**KANEPACKAGE PHILIPPINE INC.**

INVESTIGATION REPORT FORM (IRF)

Customer	ARKRAY	Attention To	REXEL ALMARIO
Item Code	84-05467A	Department	PRODUCTION
Item Description	INNER BOX F821629-1	Date of Detection	250403
Job Order Number	JO25-M-00876-3	Section Detected	QA SCREENING

ILLUSTRATION OF THE PROBLEM

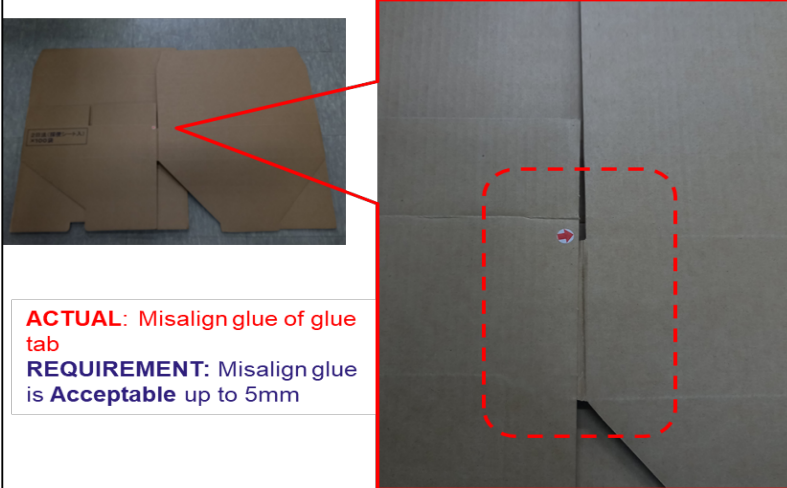
Lot Quantity (pcs)	Reject Qty (pcs)	Reject %
2100	30	1.43
Nature of Defect:		
MISALIGN GLUE		
Requirement:		
Misalign glue is Acceptable up to 5mm		
Actual		
Misalign glue of glue tab exceed set tolerance

WHY 1 : Operator got difficulty to trace the alignment during gluing process.

WHY 2 : The creasing line mark is not visible in the smooth surface can not adjust the r ndepth of creasing line to avoid bursting.

WHY 1: Request for tooling relay out regarding putting additional nick mark as guide in gluing alignment.
